# Access Compliance Report

## Public Rights-of-Way

### (Curb Ramps)

Intersection ID: 53713	Main Street: N_TRYON_ST	Cross Street: PERIWINKLE_HILL_AV	Location: E
ADA ID: AB0273D29DA9	Ramp Type: Perp	Initial Pass/Fail: Fail	Overall Compliance: No
Severity Score: 10			
Codes/Mitigation Info/Possible Solution		Field Measurements/Component Compliance

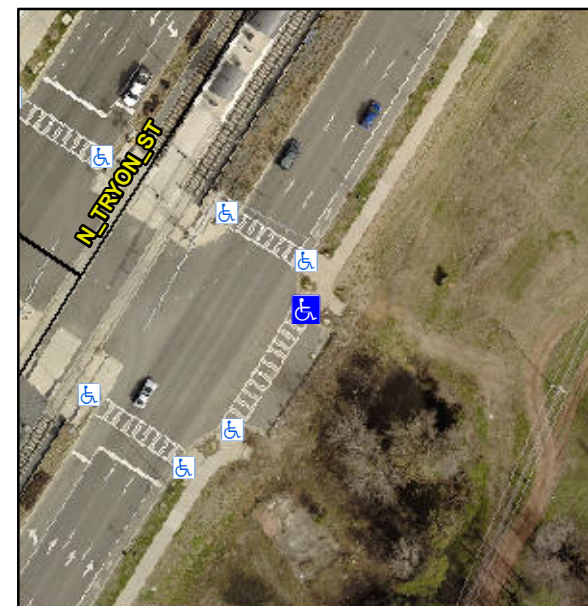
**R304.5.1**

Compliance	Description	Data	Compliance	Description	Data
N/A	Ramp Length (in)	97.0	Yes	Ramp Slope (%)	6.4
No	Ramp Width (in)	43.0	Yes	Ramp XSlope (%)	3.2
N/A	Flare Type LT	N/A	N/A	Flare Type RT	N/A
N/A	Flare Slope LT (%)	N/A	N/A	Flare Slope RT (%)	N/A
N/A	Flare Traversable LT?	N/A	N/A	Flare Traversable RT?	N/A
N/A	Landing Length (in)	N/A	N/A	DWS Provided?	N/A
N/A	Landing Width (in)	N/A	N/A	DWS Contrast?	N/A
N/A	Landing Slope (%)	N/A	N/A	DWS Length (in)	N/A
N/A	Landing X Slope (%)	N/A	N/A	DWS Full Width?	N/A
N/A	Landing Curb? (Y/N)	N/A	N/A	DWS Offset (in)	N/A
N/A	Shared Landing?	N/A			
N/A	Gutter Ponding?	N/A	N/A	Gutter Slope (%)	N/A
N/A	Gutter Lip Ht (in)	N/A	N/A	Gutter X Slope (%)	N/A
N/A	Painted X Walk1?	Yes	N/A	Painted X Walk2?	N/A
	X Walk 1 Direction	To SW		X Walk 2 Direction	N/A
N/A	X Walk 1 Width (in)	113.0	N/A	X Walk 2 Width (in)	N/A
	X Walk 1 Slope (%)	1.4		X Walk 2 Slope (%)	N/A
	X Walk 1 X Slope (%)	4.8		X Walk 2 X Slope (%)	N/A

**Remove & Replace Entire Ramp.**
